METROPOLITAN GOVERNMENT OF NASHVILLE AND DAVIDSON COUNTY

STAFF RECOMMENDATION
726 McFerrin Avenue
July 15, 2020

Application: New Construction - Infill
District: Maxwell Heights Neighborhood Conservation Zoning Overlay
Council District: 05
Base Zoning: MUN-A
Map and Parcel Number: 082080287
Applicant: Brandon Williams
Project Lead: Jenny Warren, jenny.warren@nashville.gov

Figure 6: McFerrin Avenue elevation.

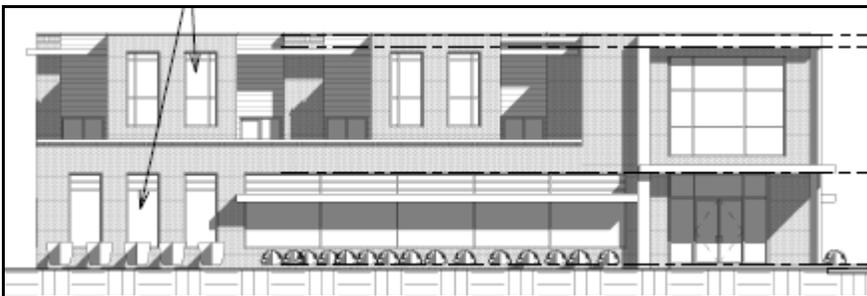
The drawings provided do not incorporate grade, and this lot does slope down significantly toward Cleveland Street. Staff recommends that drawings be provided showing how the grade will be accommodated. Staff is not able to say whether the overall height and massing is appropriate since the grade may dramatically change the design and increase the height.

While two-stories could be appropriate for at least a portion of this corner, a transitional height on the south end of the McFerrin Avenue elevation would help this design to step down to meet the heights of the one and one-and-a-half story houses with pitched roofs along this street. (Figure 7) The lot immediately to the south at 722 McFerrin is currently vacant, but the Commission expressed support for a one-and-a-half-story structure with a residential form and pitched roof on this lot. Removing some of the proposed height, even in just the final bay of this west-facing elevation could help make the increase in height less visually jarring.

Figure 8: Sidewalk requirements

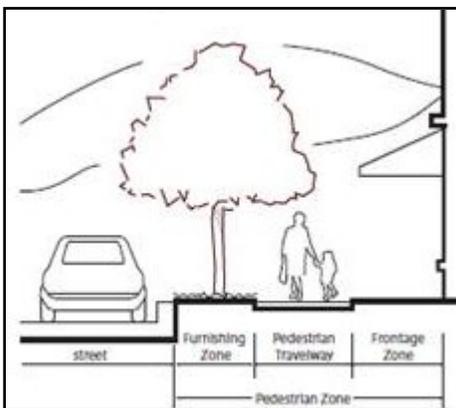
Feedback from the Planning Department indicates that a total of sixteen feet (16') of sidewalk and frontage/furnishing zones will be required along both Cleveland Street and McFerrin Avenue. This will involve a four foot (4') grass 'furnishing zone', followed by an eight foot (8') wide sidewalk, and an additional four foot (4') 'frontage zone' between

the sidewalk and front wall. (Figure 8) Further, the plan shows parking along the alley that will not meet Public Works requirements. The parking needs twenty four feet (24') from the back of the stall to the opposite right of way and the first parking stall needs to be at least forty feet (40') from the edge of the travel way on Cleveland Street. There are other Public Work requirements not specified that the proposal may or may not meet. Although MHZC does not review Public Works and sidewalk requirements, addressing these requirements will greatly change the site plan so a new site plan is recommended before final review.

Figure 9: Proposed site plan.

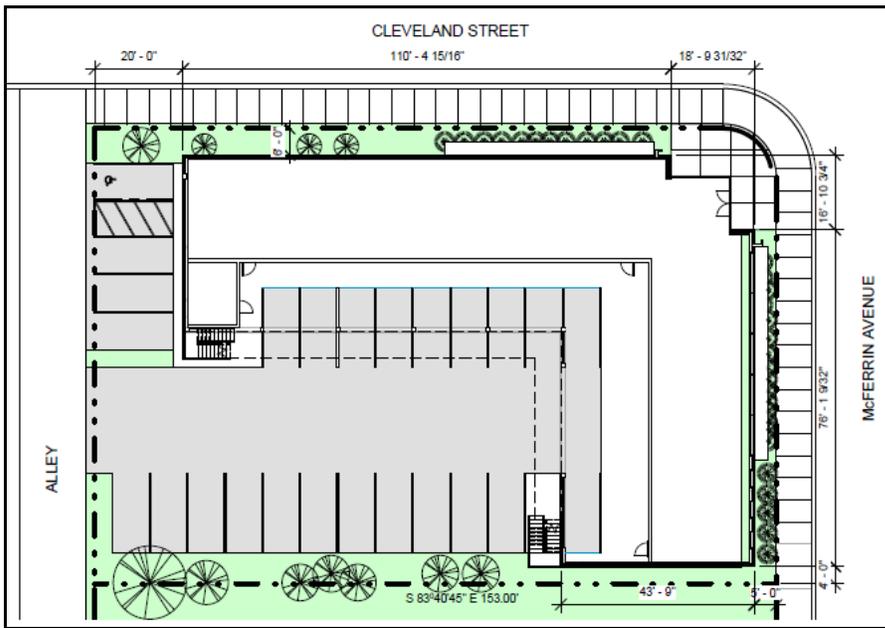
The site plan proposes a four foot (4') setback along the interior side elevation on McFerrin, staff recommends that this be five feet (5') to be roughly consistent with the side setbacks along the rest of McFerrin. Along Cleveland Street at the alley, the applicant is proposing twenty feet (20'), which staff finds appropriate. (Figure 9)

Staff recommends a new site plan reflecting staff’s recommendations and the sidewalk requirements. As these changes may change other aspects of the site plan; staff does not have a recommendation regarding setbacks at this time.

Figure 10: Cleveland Street elevation

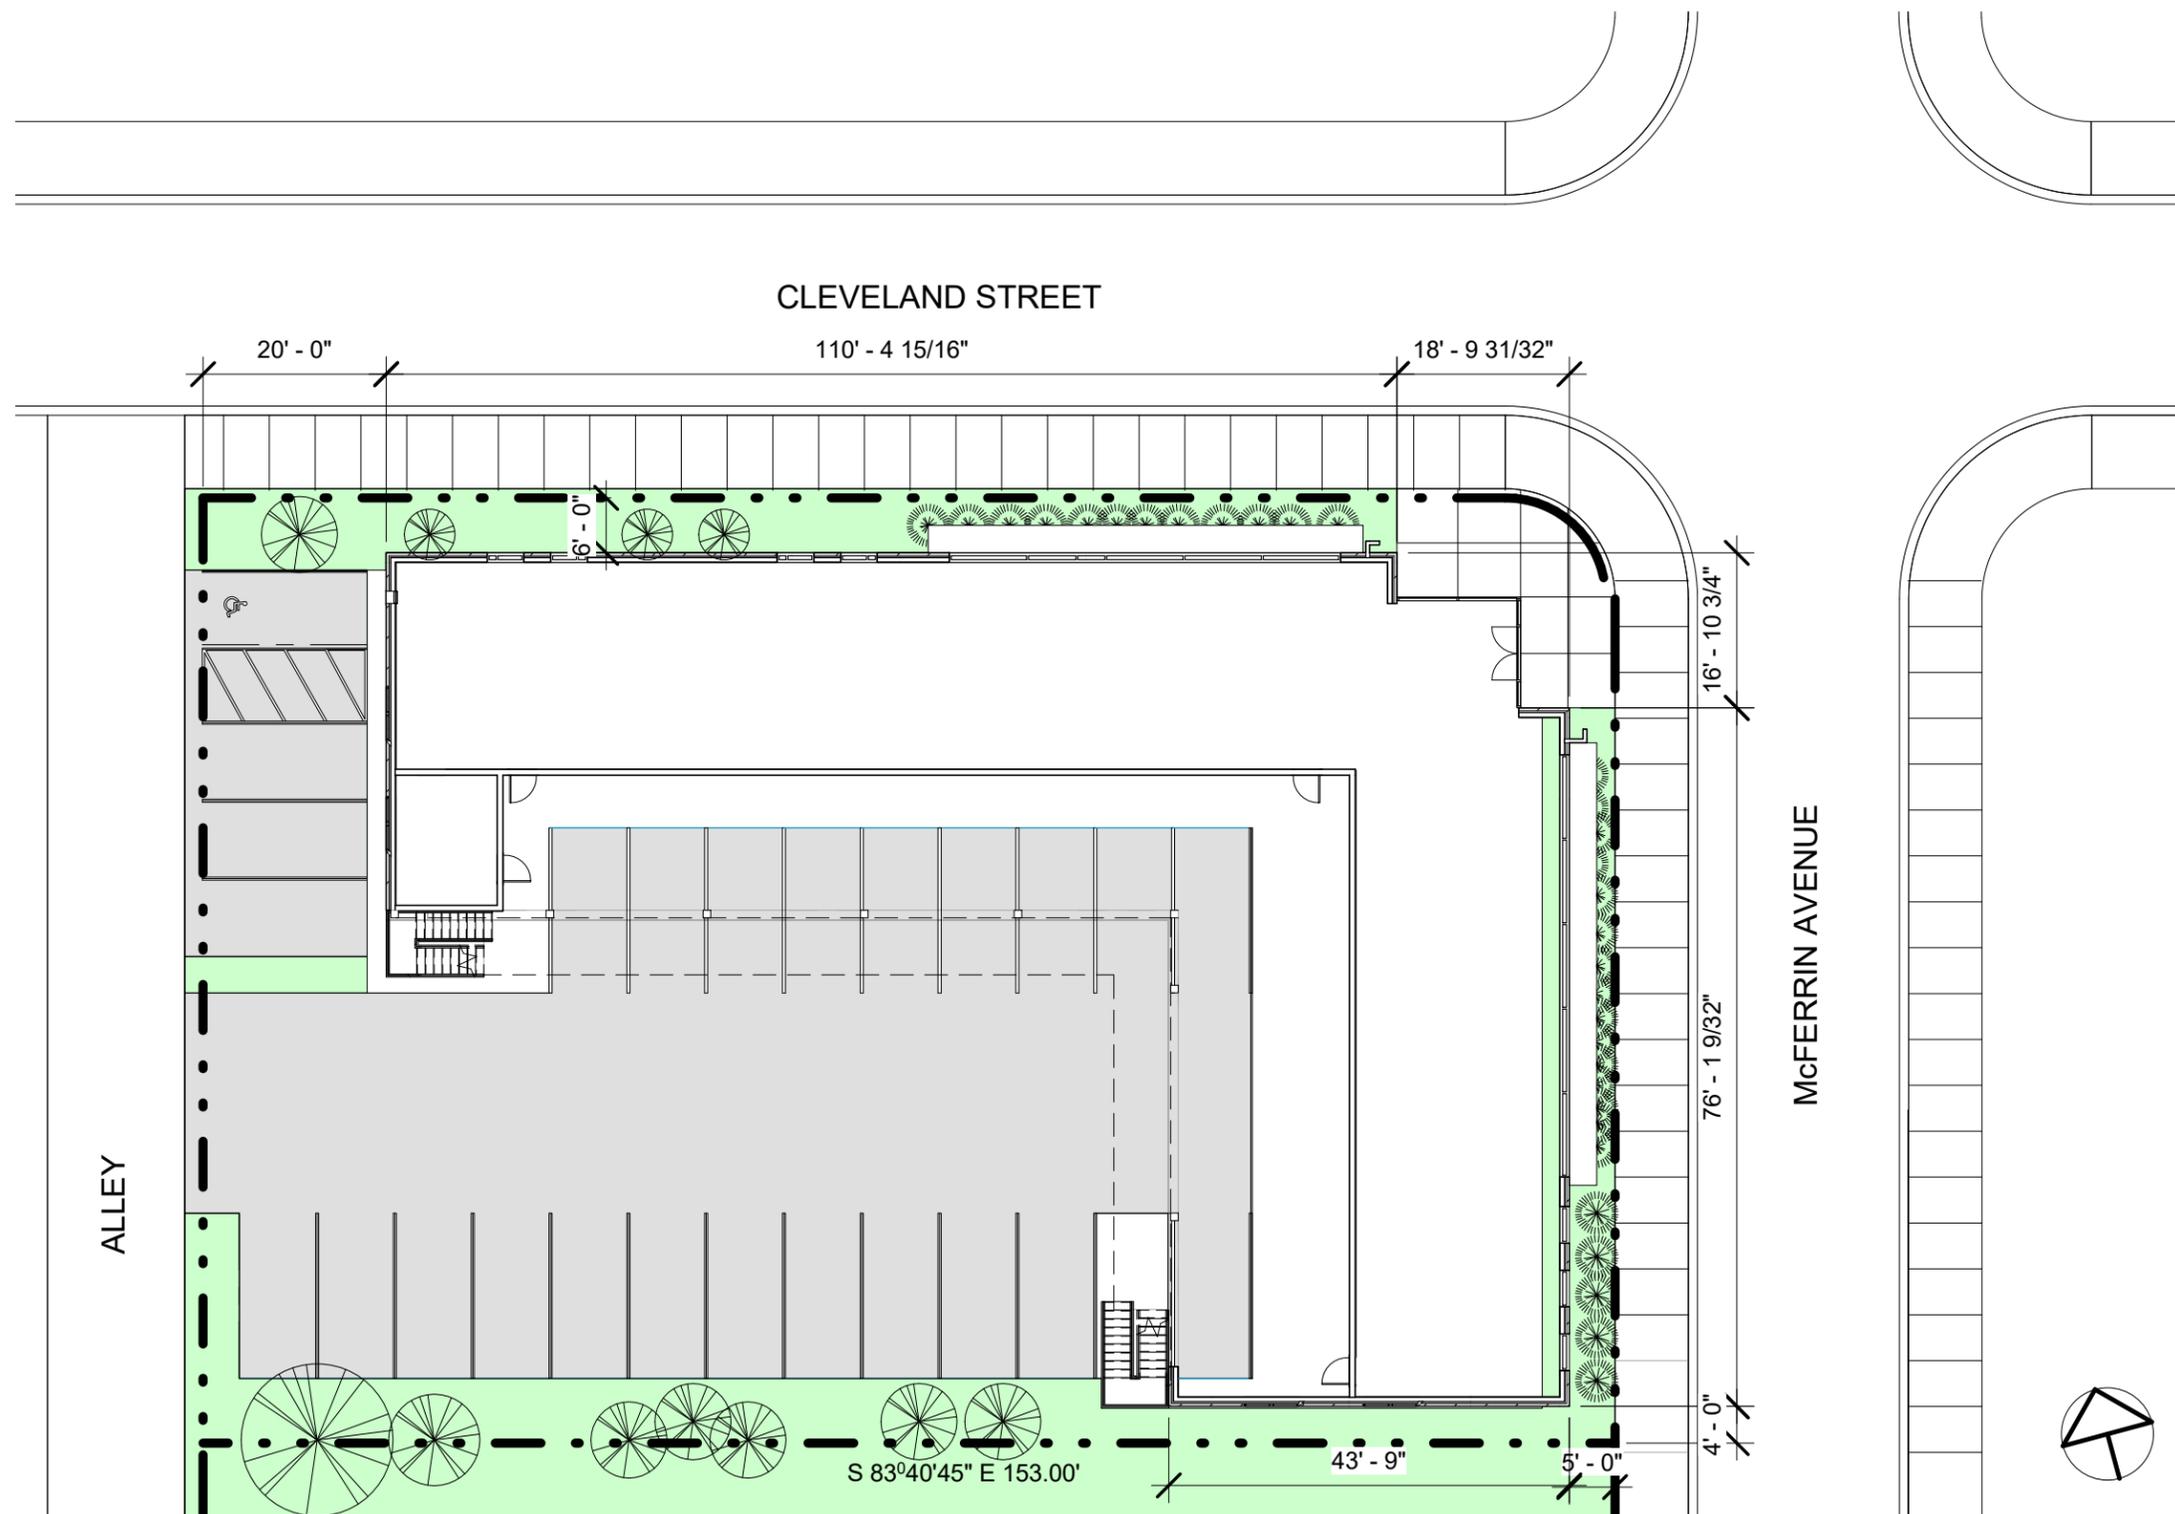
The proportions between the two levels of the building do not follow historic precedent. Historically, each level of a multi-story building was either the same height or the first level was slightly taller. With this design, the first level is eleven feet (11') tall, which is appropriate for a commercial building. However, the second level, not counting the parapet wall, is fifteen feet (15') tall creating a top-heavy look, particularly in the corner element. (Figure 10) Staff finds that the scale does not meet the design guidelines.

The building is oriented to both Cleveland Street and McFerrin Avenue, with an inset corner entry and a door opening onto McFerrin. The project should have a primary entrance along Cleveland Street, which is the commercial area, while McFerrin is more residential. Staff recommends a primary entrance -or multiple entrances- facing Cleveland Street.

As discussed under “height and scale” the proportions between levels do not follow historic precedent. The taller height of the second level, particularly the large storefront-type window on the upper-level corner, does not meet the types of proportions and rhythm of openings seen on multi-level historic commercial or mixed-use forms.
